UNITED STATES PATENT AND TRADEMARK OFFICE

APPLICATION NO.	FILING DATE	FIRST NAMED INVENTOR	ATTORNEY DOCKET NO.	CONFIRMATION NO.
10/799,342	03/11/2004	David Charles Lyons	77012-325539	6247
58506 7590 06/27/2007 FAEGRE & BENSON, LLP PATENT DOCKETING 90 SOUTH SEVENTH STREET 2200 WELLS FARGO CENTER MINNEAPOLIS, MN 55402			EXAMINER PAINTER, BRANON C	
			ART UNIT 3609	PAPER NUMBER
			MAIL DATE 06/27/2007	DELIVERY MODE PAPER

DETAILED ACTION

Reproduced from G.B. Patent No. 852,169

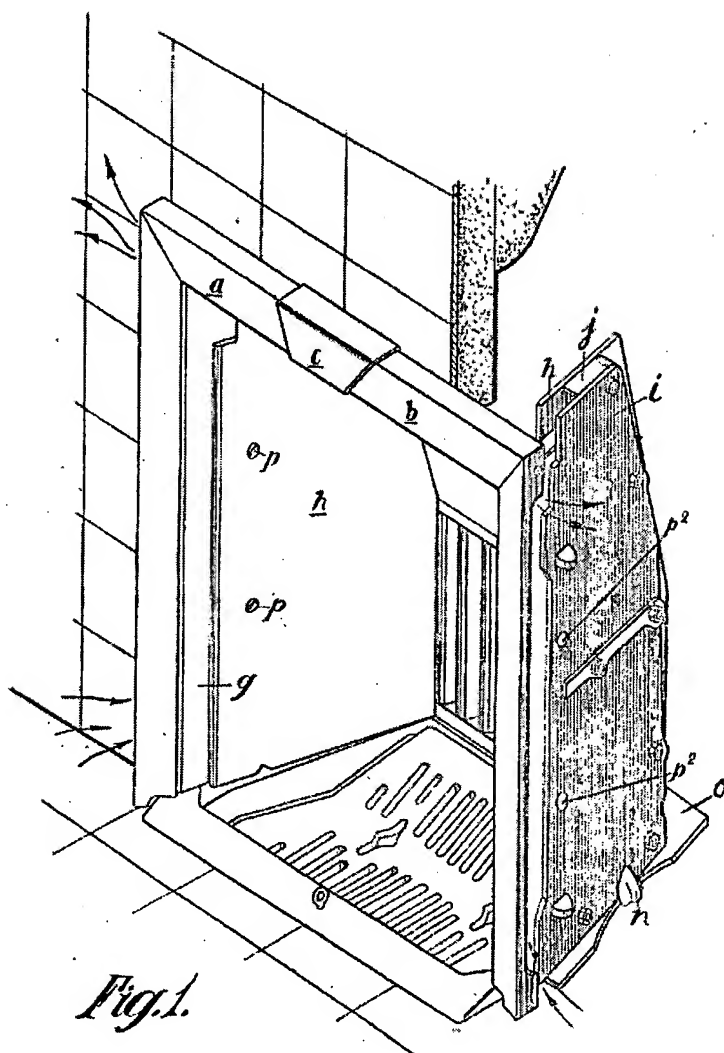
8. Claims 1-3, 9, 10, 13, 15-17, 24 and 25 are rejected under 35 U.S.C. 102(b) as being anticipated by Baxendale (G.B. Patent No. 852,169).
9. Regarding claim 1, Baxendale discloses a fireplace surround having all of the applicant's claimed structure, including:
 - a. "a first member having first and second ends..." (horizontal portion of "front member" a, Fig. 1).

- b. "...a second member having first and second ends, the first and second members being oriented generally horizontally with the first ends facing each other..." (horizontal portion of "front member" b, Fig. 1).
- c. "...a distance between the second ends of the first and second members defining a width of the surround..." (Fig. 1).
- d. "...wherein the first and second members are movable relative to each other to vary the width of the surround." ("two front members...interconnected at a midpoint in the width of the top of the fireplace by means which permit of adjustment of the width of such frame to suit the width of the fire opening," page 1, lines 19-24).

10. Regarding claim 2, Baxendale discloses a first overlap member configured to cover a spacing between the first ends of the first and second members ("member" c, Fig. 1).
11. Regarding claim 3, Baxendale discloses maximum spacing between the first ends of the first and second members no greater than the width of the overlap member (Fig. 1).

Reproduced from G.B. Patent No. 852,169

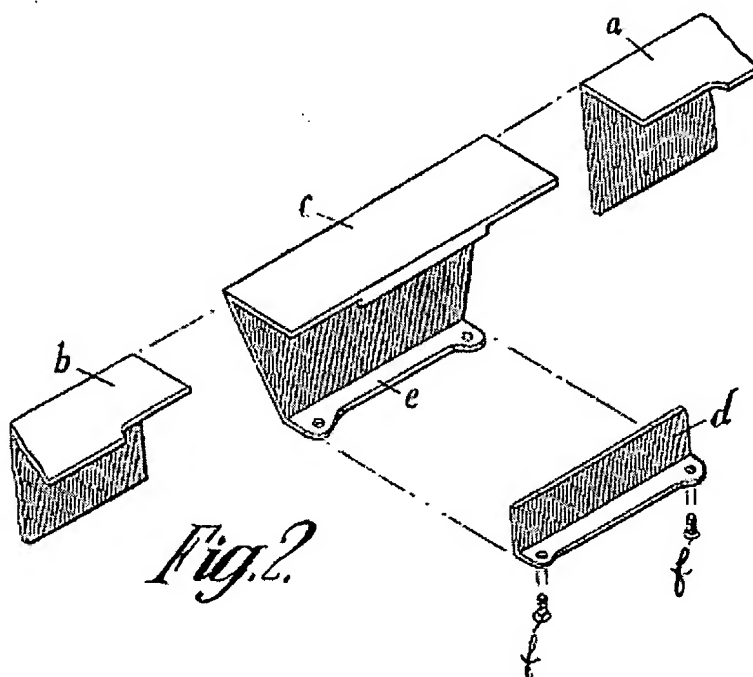
13. Regarding claim 10, Baxendale discloses a first overlap member with a front decorative surface and a rear surface including a track structure ("member" c, Fig. 2).

Fig. 1.

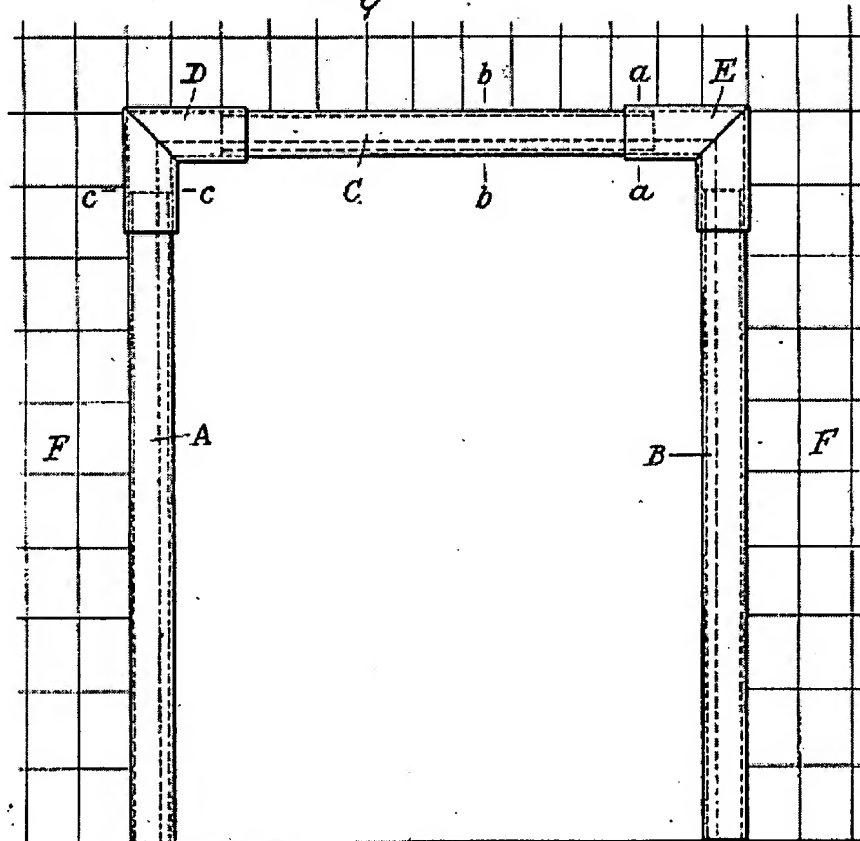
- a. "a first member having first and second ends..." ("metal length" C, amended Fig. 1). The examiner has amended Fig. 1, incorporating the plurality of pieces shown in Fig. 5 (referred to as "amended Fig. 1").

- b. "...a second member having first and second ends, the first and second members being oriented generally horizontally with the first ends facing each other..." ("metal length" C', Fig. 5, amended Fig. 1). Pollock states "I may make the lengths A, B, C in several pieces for each side or the top and join them together by fitting the meeting ends in covering pieces of thin metal which grip and conceal the joint in such a way that the lengths may be moved towards or away from each other in the covering pieces and so further enlarge or reduce the size of the frame, as will be understood from Figure 5" (page 2, lines 62-71).

- c. "...a distance between the second ends of the first and second members defining a width of the surround..." (Fig. 1, amended Fig. 1).
- d. "...wherein the first and second members are movable relative to each other to vary the width of the surround." ("metal lengths A, B, C and corner pieces D, E being so shaped or constructed that the ends of the lengths A, B, C can slide into the corner pieces D, E, the corner pieces D, E being of sufficient length to allow of the lengths A, B, C to be moved in the corner pieces D, E to suit the size of the surround F," page 2, lines 30-38).

21. Regarding claim 4, Pollock discloses first and second side members extending generally vertically from the second ends of respective first and second horizontal members ("metal lengths" A and B, Fig. 1).
22. Regarding claim 5, Pollock discloses first and second side members each including first and second ends of a length, the second ends of the first and second side members being coupled to the second end of respective first and second members, the length of the first and second side members defining a portion of a height in the surround (second ends 2 and 3, amended Fig. 1). The examiner notes that no

Reproduced from G.B. Patent No. 279,987 (Amended by examiner to highlight details)

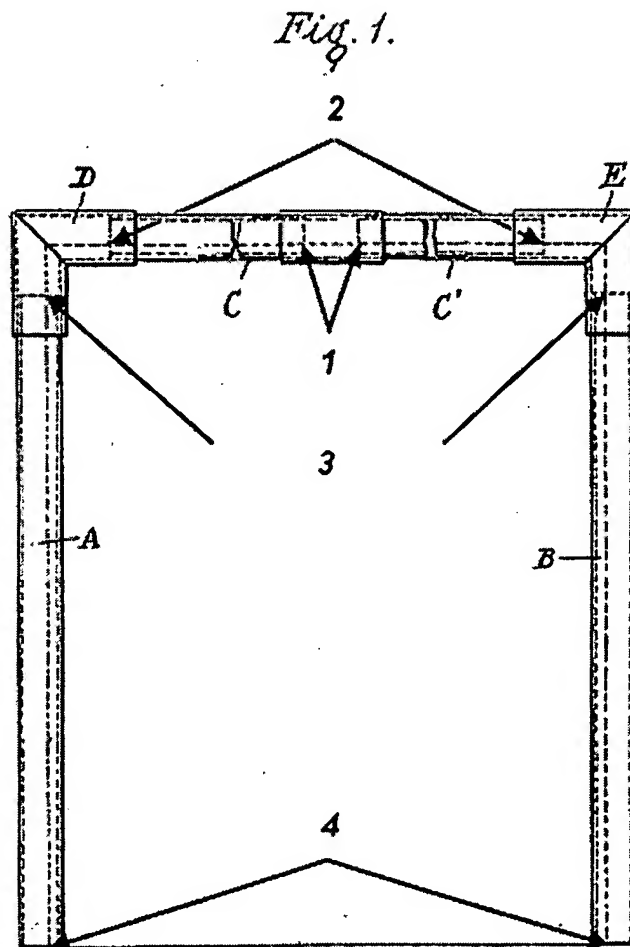
25. Regarding claim 12, Pollock discloses second and third overlap members coupled to the first ends of respective side members ("corner pieces" D and E coupled to first end 3, amended Fig. 1).
26. Regarding claim 14, Pollock discloses overlap members coupled to the second ends of the first and second members, and to the first ends of the side members ("corner pieces" D and E coupled to second ends 2 and first ends 3, amended Fig. 1).

Reproduced from U.S. Pub. No. 2003/0140570

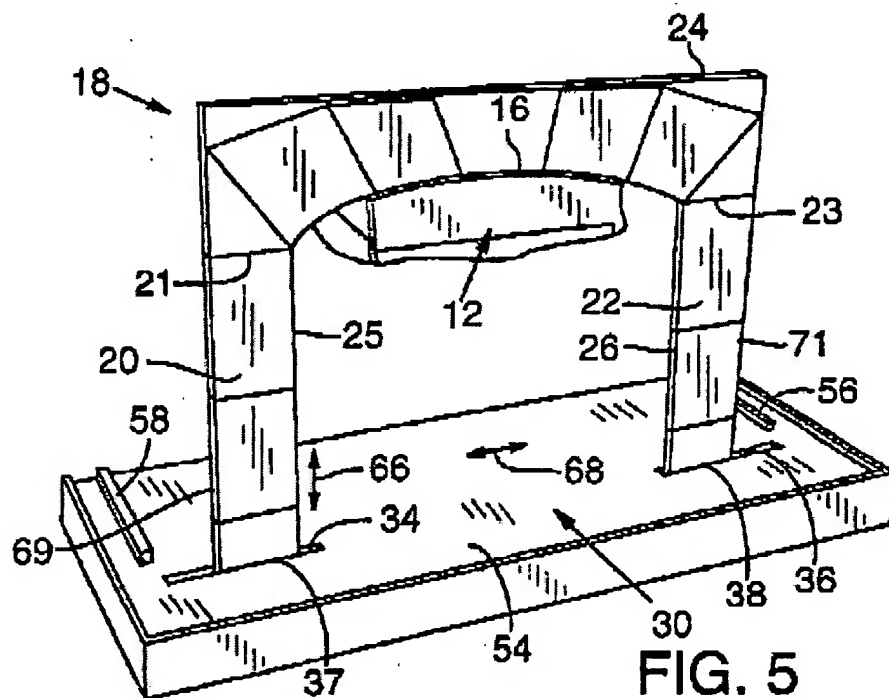
- a. "first and second side members extending generally vertically on opposing sides of a combustion chamber enclosure or fireplace..." ("surround leg portions" 20 and 22, Fig. 5).

- b. "...first and second overlap members configured to be coupled to respective first and second side members..." ("base" 30, Fig. 5). Richmond et al. states "the base may be of a plural piece construction" (paragraph 11, line 2). In this case, the base viewed from the front (as in Fig. 5) could have a left and

- c. "...wherein relative movement between the first and second side members are respective first and second overlap member adjusts a height of the surround." ("movement upwardly and downwardly" 66, Fig. 5).

34. Regarding claim 19, Richmond et al. discloses first and second side members with first ends oriented generally downward facing (“lower end portions” 37 and 38, Fig. 5), and the first and second overlap members are configured to be coupled to the first end of respective first and second side members (“slots” 34 and 36 receiving first ends “lower end portions” 37 and 38, Fig. 5).

Reproduced from U.S. Patent No. 4,254,596

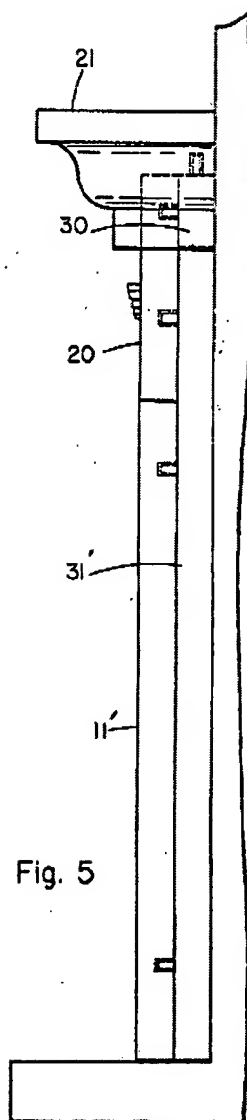
- c. Wright, et al. discloses a retaining bracket for mounting the surround to an exterior portion of the surrounding wall ("top support" 30, Fig. 1; "The assembleable mantelpiece may be installed ... by securing the top support 30 ... to the wall thereabout," column 2, lines 57-61) wherein the bracket supports the first and second members in fixed relation to one another ("male members" 32 on "top support" 30 supporting "face" 20, Fig. 1) [claim 7]; and separate retaining members for separately supporting the first and second members ("male members" 32, Fig. 1) [claim 8]. Mounting a retaining bracket as taught by Wright et al. ensures the first and second members of the surround are firmly secured in place.

- b. Pollock does not expressly disclose a mantle shelf for mounting on top of the top member.
- c. Wright et al. discloses a mantel shelf for mounting on top of the top member ("top" 21 for mounting on "face" 20, Fig. 1 and Fig. 5). Mounting a mantel shelf on top of the top member as taught by Wright et al. provides the fireplace surround owner with a traditional mantel, giving the owner additional surface area for displaying Christmas cards, candle assortments, and other decorative frippery.
